Petition: #318-23
Public Hearing:
10/17/23

PUBLIC HEARING MEMORANDUM

SUBJECT: **Petition #318-23**, for SPECIAL PERMIT/SITE PLAN APPROVAL to demolish the existing dwelling and construct three single-family attached dwellings

15-17 Jewett Place

Proposed conditions

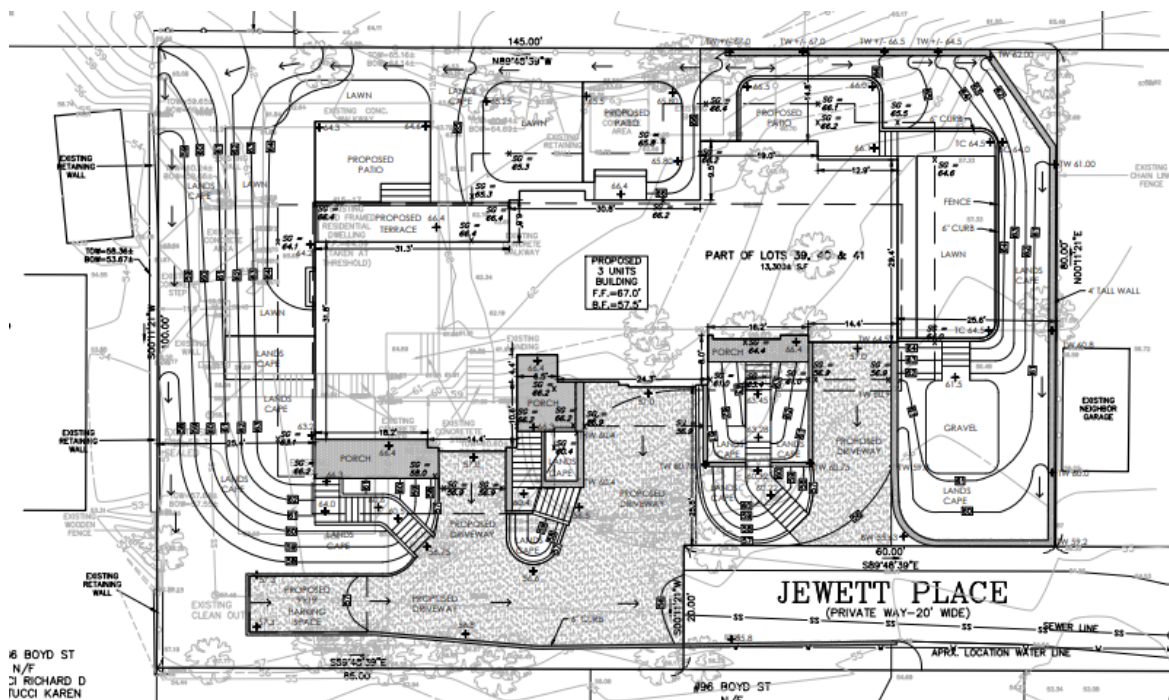
The front setback is proposed at 25.5 feet where 25 feet is required, and 27.5 feet exist now. The east setback, which is currently nonconforming at 11.6 feet where 25 feet is required, will be increased to a conforming 25.4 feet. The west setback will be reduced from 99.7 feet to 25.6 feet where 25 feet is required. The rear setback, which is currently nonconforming at 12.8 feet, will be increased to 14.8 feet but still requires relief because a minimum of 25 feet is required. Planning staff requests that the petitioner provide architectural plans showing both sides of the proposed dwelling in addition to the front and rear elevations provided in their application.

There is an existing retaining wall along the eastern property line that will be maintained. New retaining walls are proposed along the south and western lot lines, which will connect at the rear corner of the property. The wall along the western lot line reaches a maximum height of four feet. Because that section of wall is located within a setback, relief is required. The architectural plans indicate that landscaping will be installed along the eastern and western property lines and near each front entrance on Jewett Place. Fencing will be installed to enclose an area of lawn and patio associated with the unit on the right. The Planning Department requests that the petitioner provide a landscape plan or more detailed information about the landscaping proposed throughout the site including details about any tree removal and replacement on the site.
